Well Name: EAGLE 35 D FEDERAL	Well Location: T17S / R27E / SEC 35 / NWNW /	County or Parish/State: EDDY / NM
Well Number: 17	Type of Well: OIL WELL	Allottee or Tribe Name:
Lease Number: NMLC067849	Unit or CA Name:	Unit or CA Number:
US Well Number: 300153326700S1	Well Status: Producing Oil Well	Operator: REDWOOD OPERATING LLC

**Notice of Intent**

Type of Action: Plug and Abandonment

## Plug Abandonment NOI Proposed

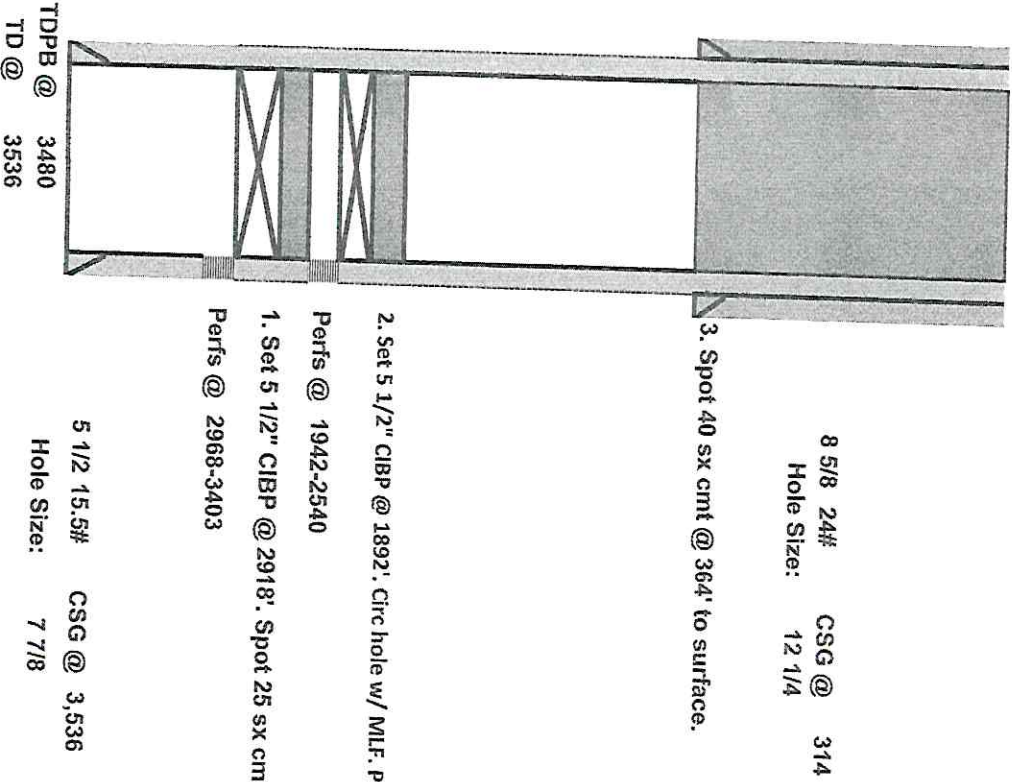
1. Set 5 1/2" CIBP @ 2918'. Spot 25 sx cmt @ 2918-<sup>2671'</sup>~~2718'~~. WOC & Tag
2. Set 5 1/2" CIBP @ 1892'. Circ hole w/ MLF. Pressure test csg. Spot 25 sx cmt @ 1892-~~1692'~~. <sup>1645'</sup>
3. Spot 40 sx cmt @ 364' to surface.
4. Cut off well head, verify cmt @ surface, weld on Dry Hole Marker.
